CENTRAL WAREHOUSE &
MAINTENANCE FACILITY

FUEL ISLAND
UPGRADE

ADEQUATE
OUTFALL

DATE	04/29/11
SCALE	1" = 60'
DWN. KAB	CHK. WSS
PROJ. No.	
DWG. No.	C008

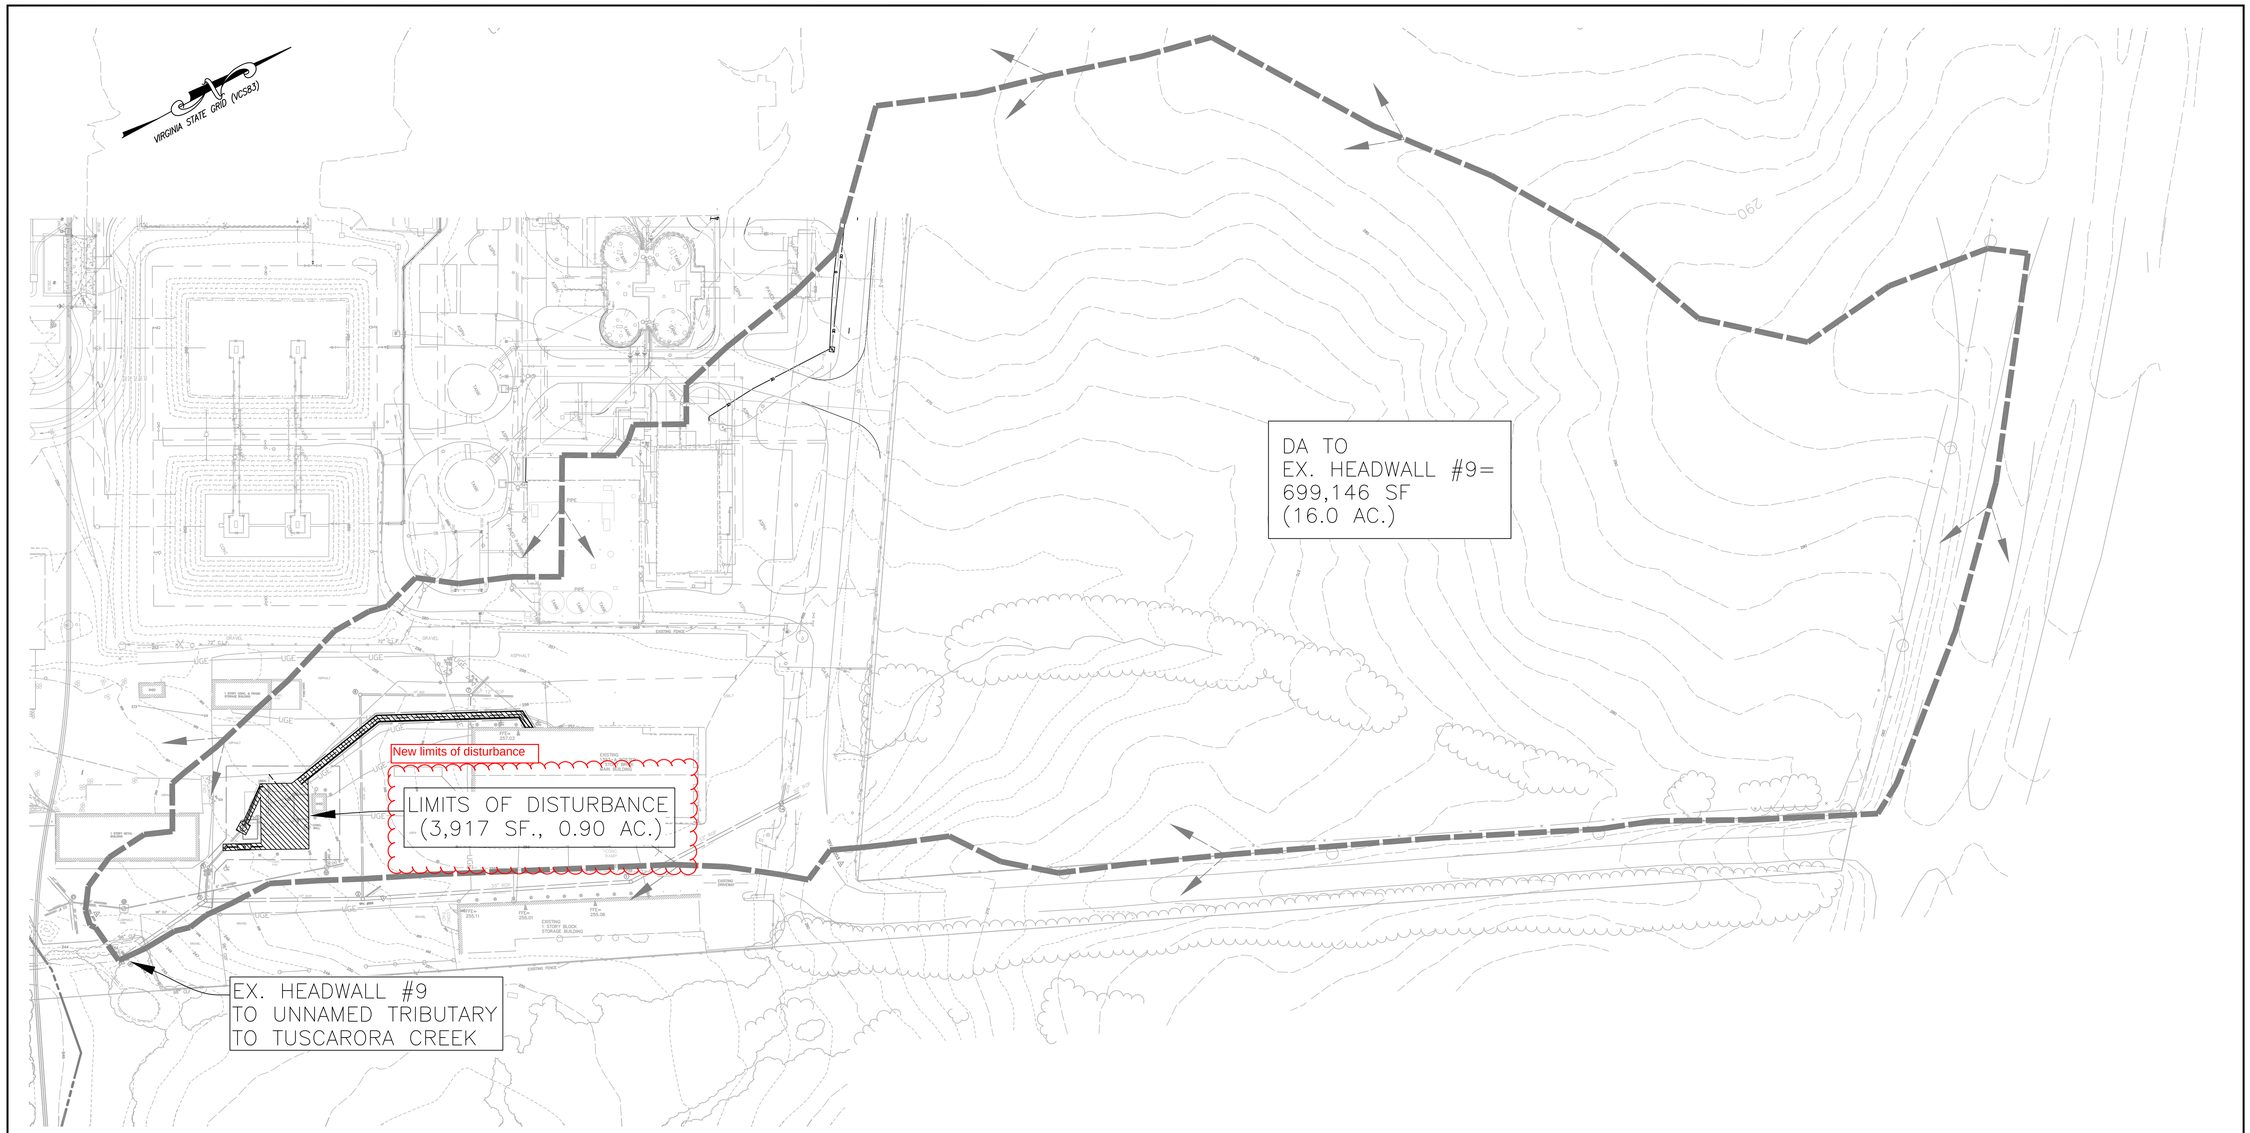
calculations revised to reflect new limits of disturbance
